50-280

INFORMATION CONCERNING HIGH DENSITY SPENT FUEL
STORAGE RACKS....INS RESPONSE TO NRC QUESTIONS
SUBMITTED BY LTR DTD 8/25/77.....

RACK FINITE ELEMENT MODEL CROSS BRACING
FIGURE 8-4

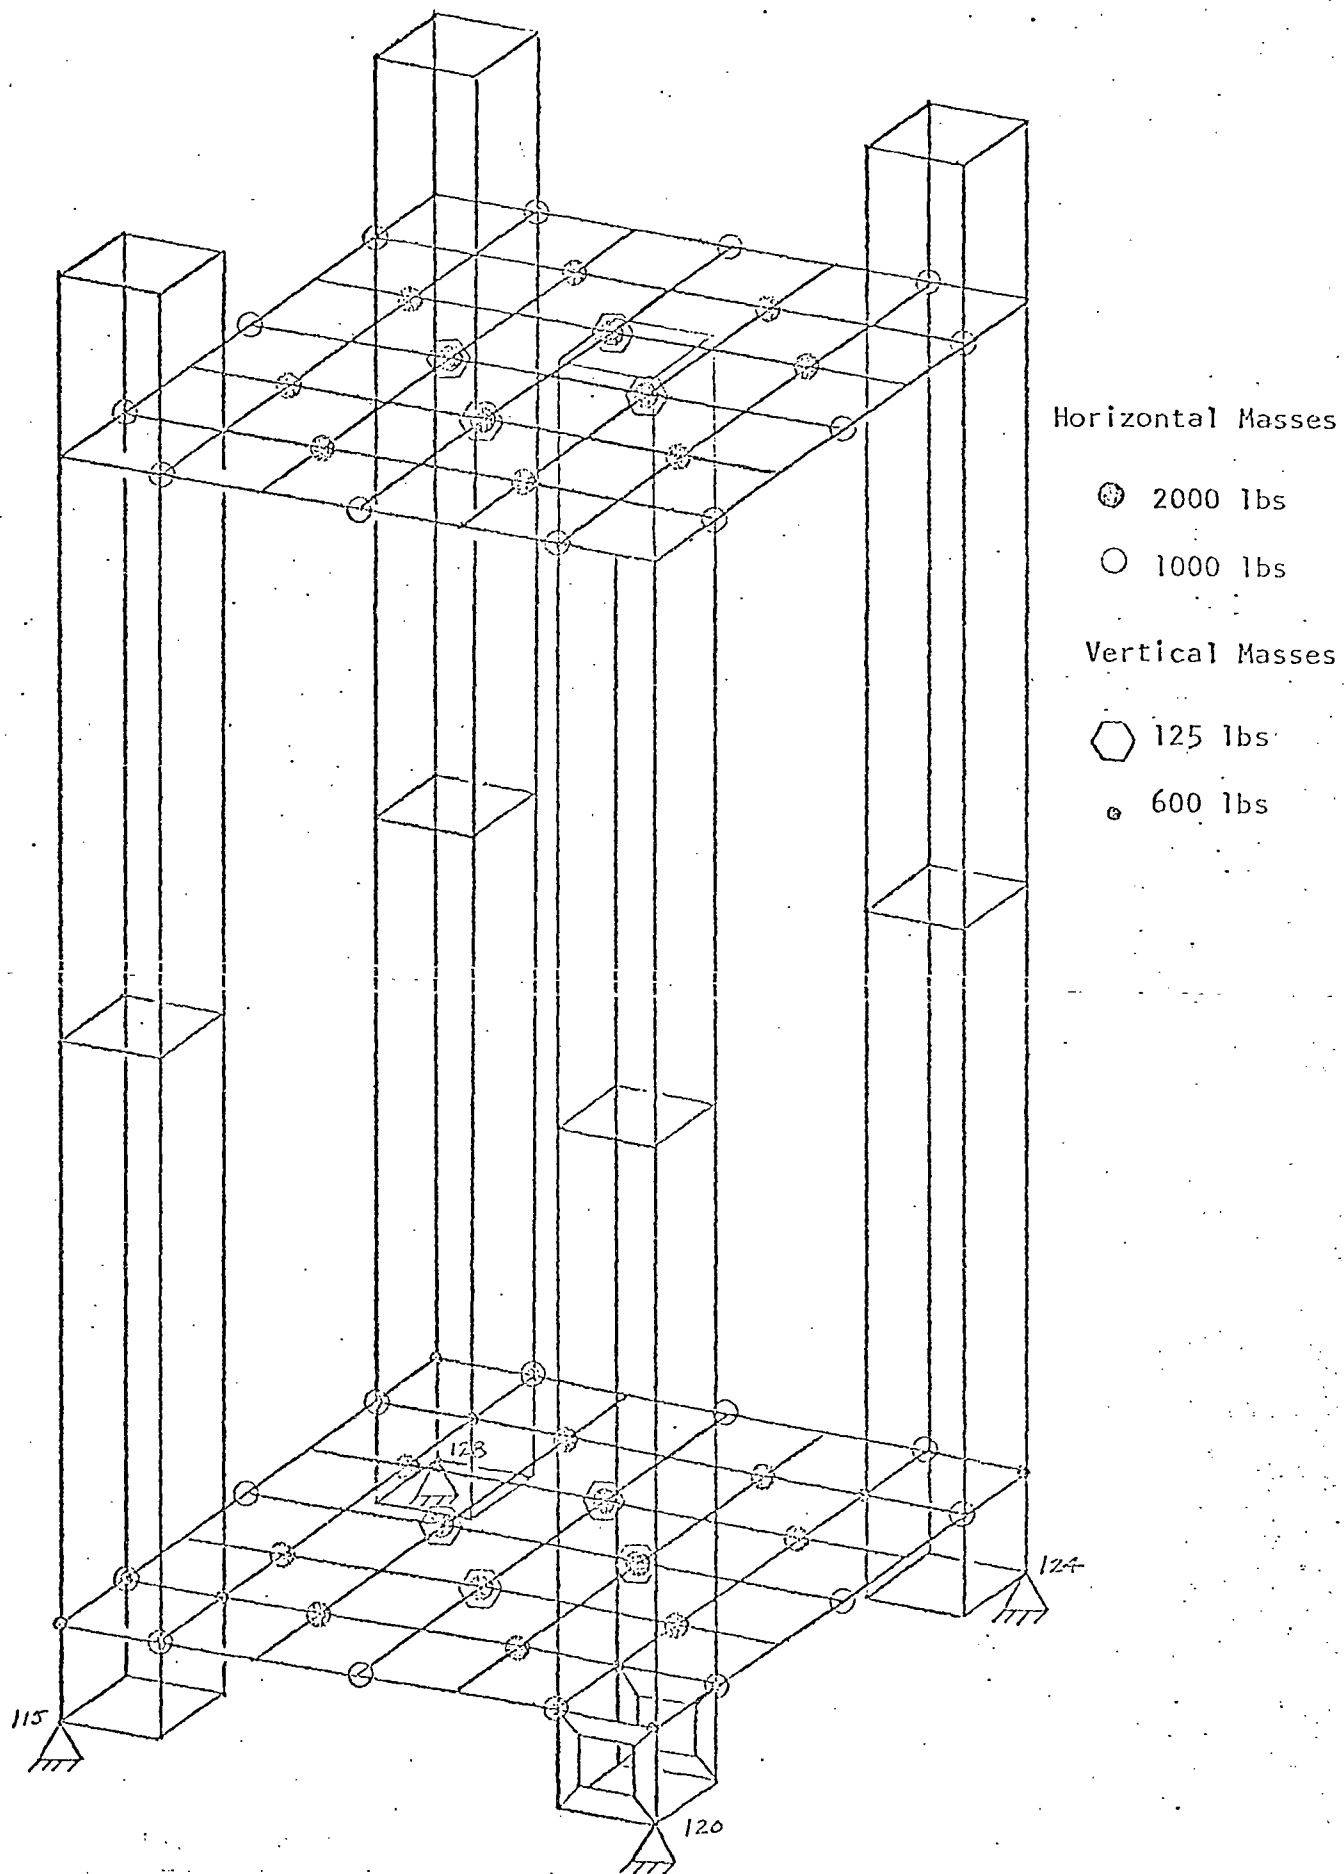
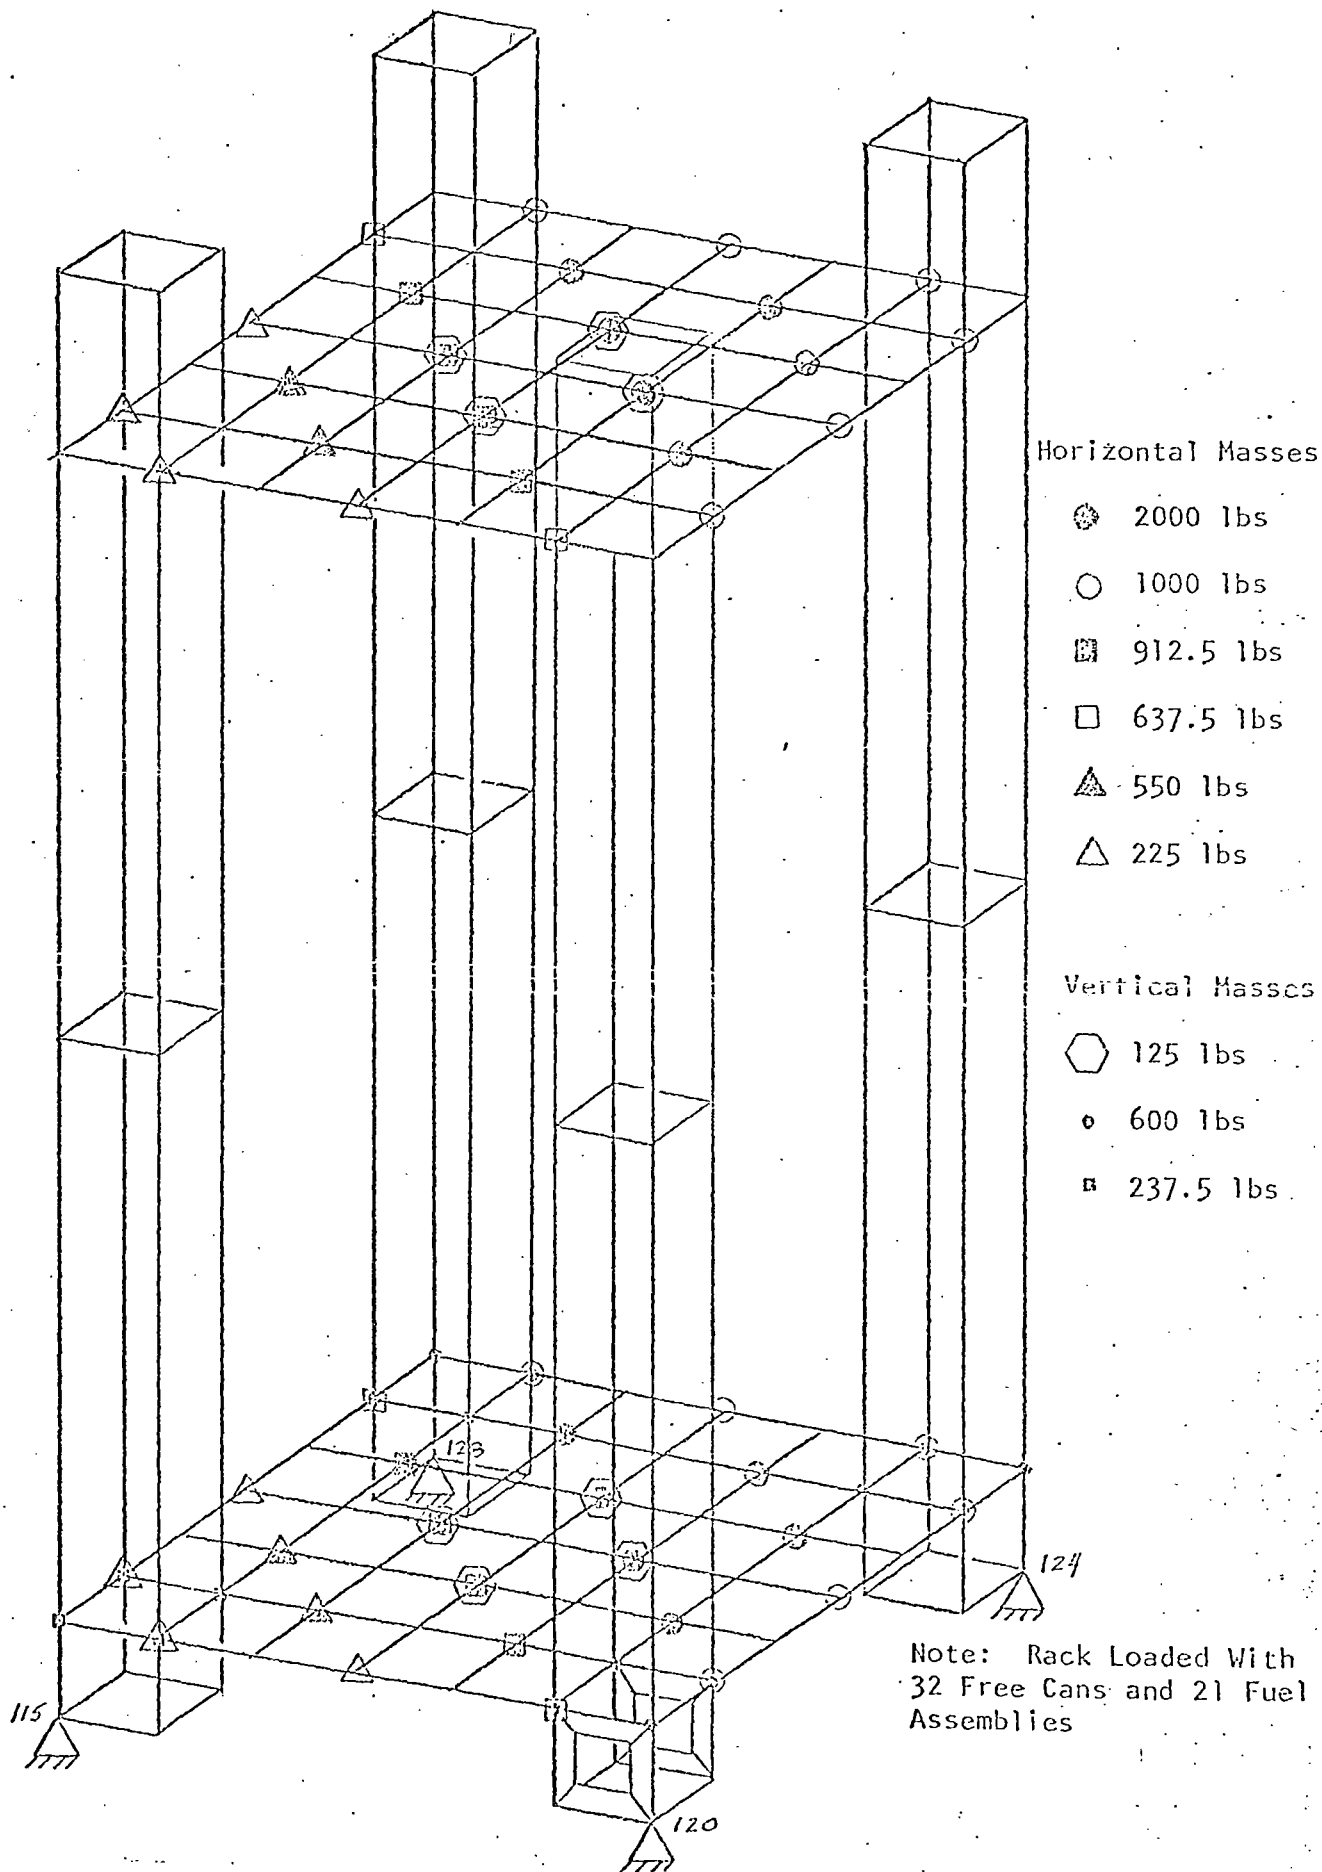
Question 8: Provide a description of the dynamic model of the rack, fuel pool system clearly showing the boundary conditions. Also indicate the damping values used in your analysis. Since the proposed rack system is inherently weak in torsion discuss what considerations were given to obtain the highest torsional effects due to possible non-uniform mass distribution.

Response: For the dynamic analysis, the fuel storage rack structure has been mathematically modeled as a three dimensional finite element structure consisting of discrete three dimensional elastic beam and plate elements interconnected at a finite number of model points as shown in Figures 8.1 through 8.4. Figures 8.5 and 8.6 show the model boundary conditions and the lumped mass distribution used in the seismic analysis of the fully loaded and partially loaded fuel storage racks respectively. The damping values used in the seismic analysis of the high density fuel storage racks are four percent for the Operating Basis Earthquake (OBE) and six percent for the Safe Shutdown Earthquake (SSE). The NRC Regulatory Guide 1.61 permits damping values of two percent for OBE and four percent for SSE for welded steel structures functioning in air. These damping values are increased by two percent since the fuel storage racks are welded stainless steel structures completely submerged in water. This two percent increase in damping value for submerged structures is based on Section 6.4 of "Fundamentals of Earthquake Engineering" by N. M. Newmark, and E. Rosenblueth.

The fuel storage rack (six by six array of fuel storage cells) consists of upper and lower grid structures connected to each other by means of four corner cells and the diagonal bracing members. The fuel storage rack thus structurally becomes equivalent to a box shaped structure which is inherently strong in torsion. The torsional effects due to possible non-uniform mass distribution are considered in the analysis by analyzing the partially loaded rack. (Figure 8-6).

FUEL POOL STRESS POINT
LOCATIONS FOR TABLE 11-1
FIGURE 11-1

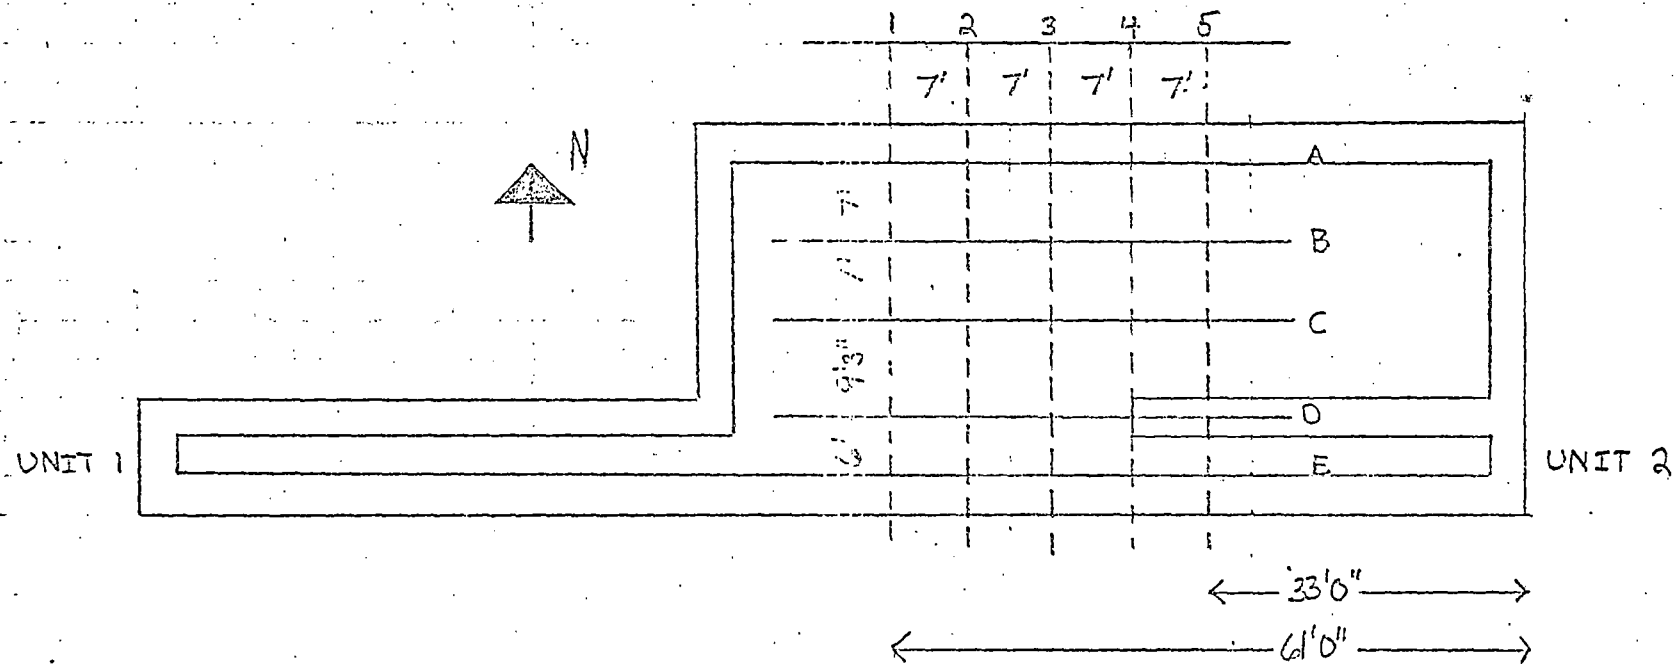
Question 11: On page 38 in Section 7.1 provide a summary of stresses of the supporting pool structure indicating the load combinations and the corresponding acceptance criteria. Indicate whether or not the maximum temperature or the thermal gradient in the pool walls and the base slab as originally designed are exceeded as result of this proposed expansion.

Response: A summary of stresses of the supporting pool structure is provided in Table 11-1. The points given are in the regions where the maximum stresses occur as shown in Figure 11-1.

The allowable stresses are based on the minimum sampled coupon strength of 43,600 psi and the acceptance criteria stated in ACI 318-63. It should be noted that with the new high density spent fuel storage racks, the mat loadings are lower than those originally calculated. This is due to the different analytical model used. For the high density spent fuel storage rack loadings, the model accounted for the detailed location of both the pilings and the fuel rack embedments in the mat. This resulted in a significant portion of the load due to spent fuel to be transmitted to the pilings without inducing mat bending. In the analysis for the original loading the rack loads were spread uniformly over the mat, and the pilings were lumped at discrete locations which were further apart than the actual pile spacing. The method used to calculate the mat loadings from the new high density spent fuel storage racks represents the as built conditions at Surry.
